UNITED STATES PATENT AND TRADEMARK OFFICE

APPLICATION NO.	FILING DATE	FIRST NAMED INVENTOR	ATTORNEY DOCKET NO.	CONFIRMATION NO.
10/560,588	12/12/2005	George Marmaropoulos	US030177US	7162
24737 7590 08/27/2007 PHILIPS INTELLECTUAL PROPERTY & STANDARDS P.O. BOX 3001 BRIARCLIFF MANOR, NY 10510			EXAMINER TSUKERMAN, LARISA Z	
			ART UNIT 2833	PAPER NUMBER
			MAIL DATE 08/27/2007	DELIVERY MODE PAPER

Office Action Summary

DETAILED ACTION

Attachment

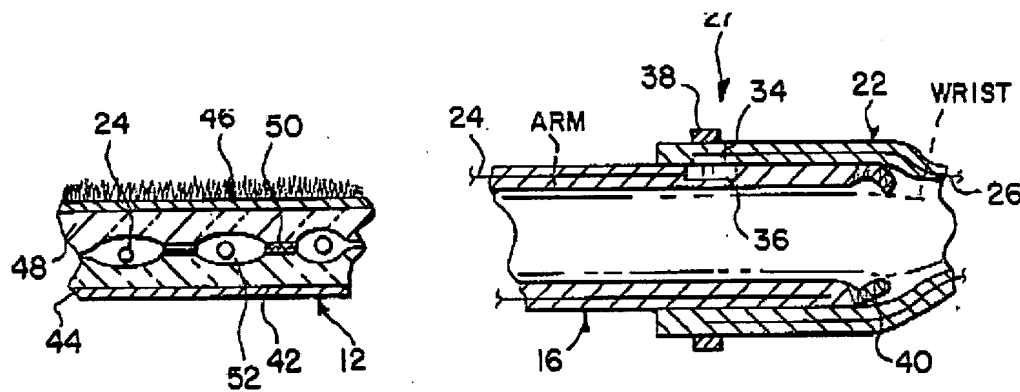
Claim 1 is rejected under 35 U.S.C. 102(b) as being anticipated by Nash et al. (4777344).

In regard to claim 1, Nash et al. disclose a fabric interconnect (not marked, see Fig.4) for use to interconnect a garment 22 (glove) having fabric electrodes 26 and an electronics enclosure 16/10 having a conductive area 24/36 on its outer surface that is connected to a circuit (see Fig.1), the fabric interconnect comprising: a portion (not marked, see Fig.4) of the garment 22 including a first inner surface FIS26 (see Attachment), which is substantially electrically conductive, coupled to the fabric electrodes 26; and a second inner surface that is substantially electrically non-conductive 34, wherein the first inner surface FIS and the second inner surface 34 are

seamlessly manufactured to form a chamber C, and wherein when the electronics enclosure 16/10 is inserted into the chamber C in a predetermined position, causes the conductive area of the electronics enclosure 24/27 and the first inner surface FIS26/27 to make contact and form an interconnection between the fabric electrodes of the garment and the circuit.

a first inner surface FIS26 chamber C
